Access Compliance Report

Public Rights-of-Way

(Curb Ramps)

Intersection ID: 10020374	Main Street: BALLANTYNE_CORPORATE_PL	Cross Street: N/A	Location: SE
ADA ID: 7DF4A0D04EAF	Ramp Type: Perp	Initial Pass/Fail: Fail	Overall Compliance: No
		Severity Score: 22.5	
Codes/Mitigation Info/Possible Solution		Field Measurements/Component Compliance

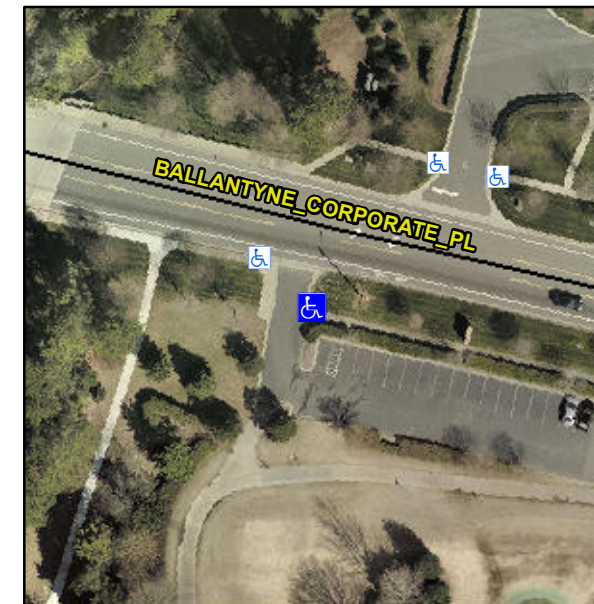
R304.5.1, R304.2.2

Compliance	Description	Data	Compliance	Description	Data
N/A	Ramp Length (in)	59.0	No	Ramp Slope (%)	10.3
No	Ramp Width (in)	47.5	Yes	Ramp XSlope (%)	2.8
N/A	Flare Type LT	N/A	N/A	Flare Type RT	N/A
N/A	Flare Slope LT (%)	N/A	N/A	Flare Slope RT (%)	N/A
N/A	Flare Traversable LT?	N/A	N/A	Flare Traversable RT?	N/A
N/A	Landing Length (in)	N/A	N/A	DWS Provided?	N/A
N/A	Landing Width (in)	N/A	N/A	DWS Contrast?	N/A
N/A	Landing Slope (%)	N/A	N/A	DWS Length (in)	N/A
N/A	Landing X Slope (%)	N/A	N/A	DWS Full Width?	N/A
N/A	Landing Curb? (Y/N)	N/A	N/A	DWS Offset (in)	N/A
N/A	Shared Landing?	N/A			
N/A	Gutter Ponding?	N/A	N/A	Gutter Slope (%)	N/A
N/A	Gutter Lip Ht (in)	N/A	N/A	Gutter X Slope (%)	N/A
N/A	Painted X Walk1?	No	N/A	Painted X Walk2?	N/A
	X Walk 1 Direction	To NW		X Walk 2 Direction	N/A
N/A	X Walk 1 Width (in)	N/A	N/A	X Walk 2 Width (in)	N/A
	X Walk 1 Slope (%)	1.5		X Walk 2 Slope (%)	N/A
	X Walk 1 X Slope (%)	2.9		X Walk 2 X Slope (%)	N/A

Remove & Replace Entire Ramp.
